**TOWN OF ERIE
BOARD OF TRUSTEES
April 23, 2019**

SUBJECT: Spring Hill Sketch Plan - A Sketch Plan represents a generalized land use plan and layout for the area proposed to be included within a subdivision. A Sketch Plan application is required to allow for an early, informal evaluation of a proposed subdivision before detailed planning and engineering work has occurred.

PURPOSE: Review and comment on a Sketch Plan application for of 632 lots and 33 tracts as well as right of way, parks, and open space.

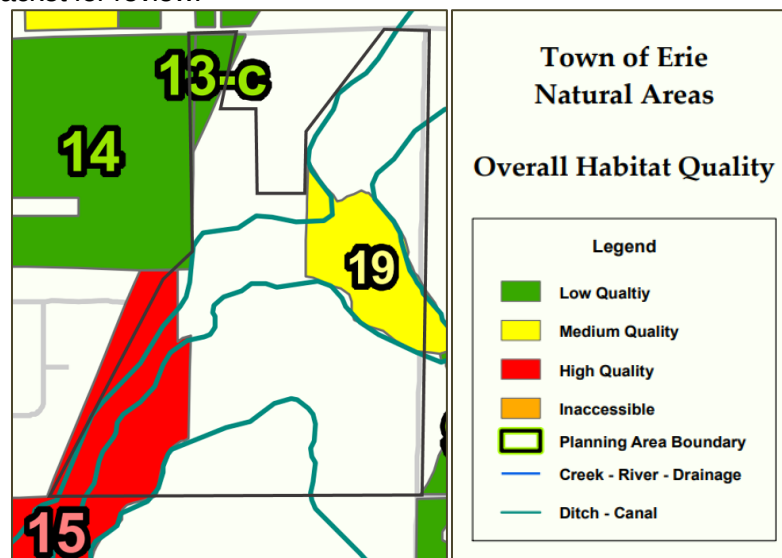
The proposed plan does not align with the Comprehensive Plan Land Use designation for this property. The approximately 70 acre area south and west of the Cottonwood Extension ditch is shown as Agriculture on the Comprehensive Plan. According to the Comprehensive Plan farming, ranching, and other agriculturally related uses and very low density rural residential uses are appropriate in this area. Also, lands designated Agriculture “serve a vital role in defining the history and character of Erie and should be maintained where viable, to serve as gateways and buffers, preserve vistas, and retain the desired character of the Town.” Within this area the sketch plan shows the western edge, the areas adjacent to the western two ditches (Lower Boulder Ditch and the Boulder/Weld Ditch), as open space and develops the remainder at a density consistent with an LDR land use designation. The LR Zone Designation (which defines allowed uses and development standards for those uses) does not negate the need for the subdivision plan to be consistent with the Comprehensive Plan. A Comprehensive Plan amendment allowing the change in Land Use designation from this area would be required to be approved for this subdivision plan to conform to the Comprehensive Plan.

The Land Use Plan Map identifies, with a green flag, a future Saint Vrain Valley School District school site on the property. The sketch plan anticipates and provides a 10 acre elementary school site.

Overall Sketch Plan

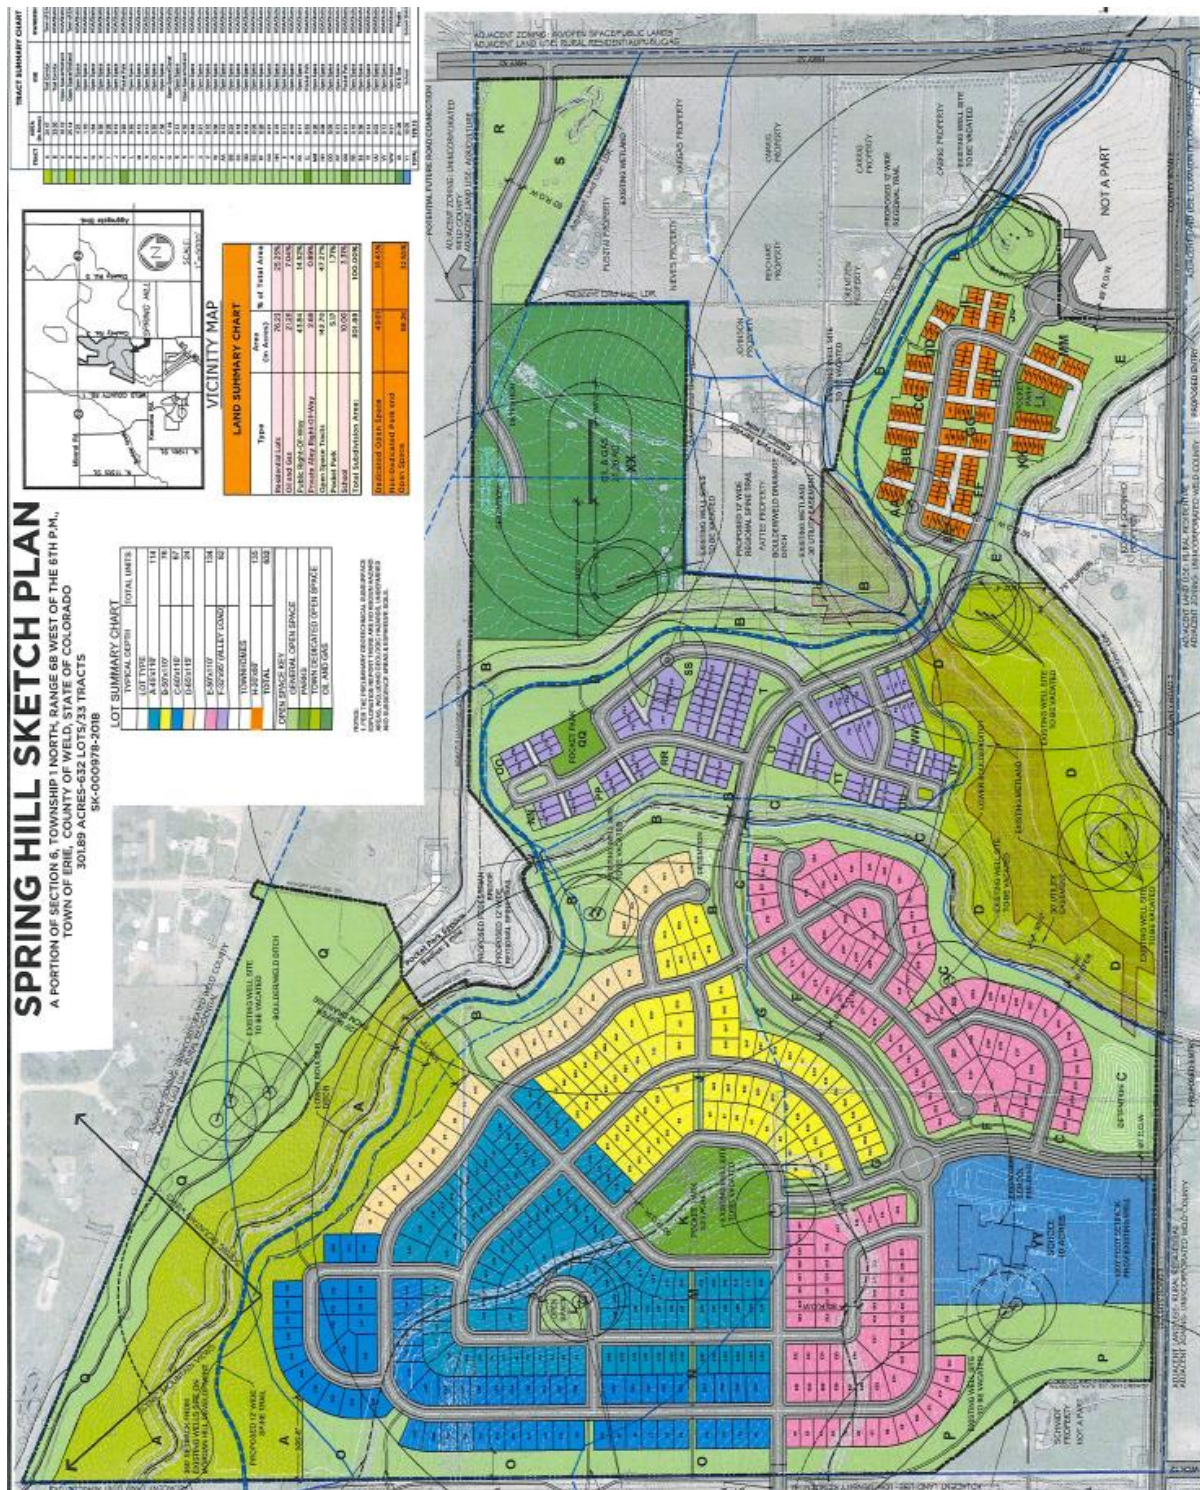
The UDC requires 4 housing types or 3 housing types and one variation on a development of this size however; the annexation agreement for this property modified the requirement by stating “the property shall be required to provide not more than one (1) housing type and two (2) housing type variations”. By providing single family detached housing with a range of lot sizes, front and alley loaded variations, as well as townhouses the applicant will exceed the annexation agreement.

With 632 dwelling units included in the Sketch Plan the overall parks and open space dedication requirements apply: Neighborhood Park 5.48 acres; Pocket Park 0.91 acres; Community Park 9.13 acres; Open Space 31.05 acres. A Neighborhood Park is not required since the 7 acre minimum was not reached however, the Neighborhood Park Land and Development Construction Cost Fee will apply. The Community Park is not required as the 30 acre minimum is not met.

The applicants proposed Sketch Plan includes construction of the roads within the subdivision which connect County Road 3 to the east and the Morgan Hill property to the south. Improvements to adjacent existing roads will be necessary.

Within the subject property the proposed Sketch Plan anticipates the closure of the existing oil and gas wells and associated facilities. These operations are proposed to be relocated to a 21.26 acre area in the northwest portion of the property where a separate access point into Highway 52 would be developed.

Other oil and gas operations exist to the south of the project within the Morgan Hill development. The Sketch Plan shows a 1,000 foot setback from the wells located south of the school site and a 350 foot setback from the wells on the west side of Morgan Hill.
